# DEVELOPMENT APPLICATION ASSESSMENT

<b>Application number</b>	<b>DA-72/2013</b>
<b>Site address</b>	<b>113 Macpherson Street Bronte, known as the 'Bronte RSL site'</b>
<b>Proposal</b>	<b>Demolition of the existing Bronte RSL and construction of a six (6) storey mixed-use building consisting of basement parking, ground floor retail, first floor Club, residential units above and subdivision.</b>
<b>Date of lodgement</b>	<b>7 March 2013</b>
<b>Owner</b>	<b>Bronte RSL Sub-branch</b>
<b>Applicant</b>	<b>Winston Langley Burlington</b>
<b>Submissions</b>	<b>425 submissions; 3 Petitions totalling 2098 signatures in opposition 4 letters of support</b>
<b>Cost of works</b>	<b>\$24,768,810</b>
<b>Issues</b>	<b>Land Use (Supermarket and Club), Bulk and Scale, Traffic/Parking, Design/Character</b>
<b>Recommendation</b>	<b>That the application be REFUSED</b>

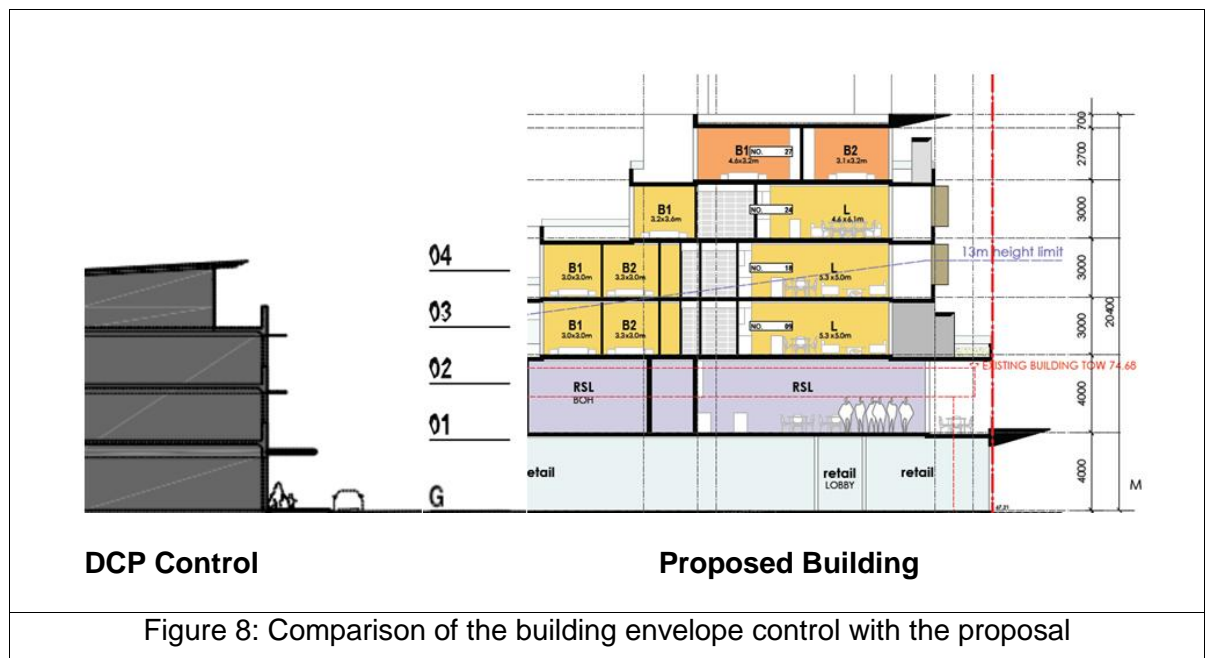
The objective of the control is to ensure the ground floor small shop character of the area prevails. The proposal does not achieve this. The first floor club contains gaming areas, function rooms, a bar, and a terrace at the front of the building for almost its full length (over 28 metres).

By comparison to a well known example, the first floor terrace at Ravesi's Hotel Bondi Beach has a length of 17m fronting Campbell Parade (and 35m facing Hall Street).

The first floor positioning of the club is not satisfactory and is the by-product of seeking excessive retail space on the ground floor. Had the club been located on the ground floor with residential levels above (and perhaps retail adjacent on the ground floor or below Macpherson Street) there would be inherently a much greater satisfaction of the planning controls.

The club is therefore not supported at the first floor level.
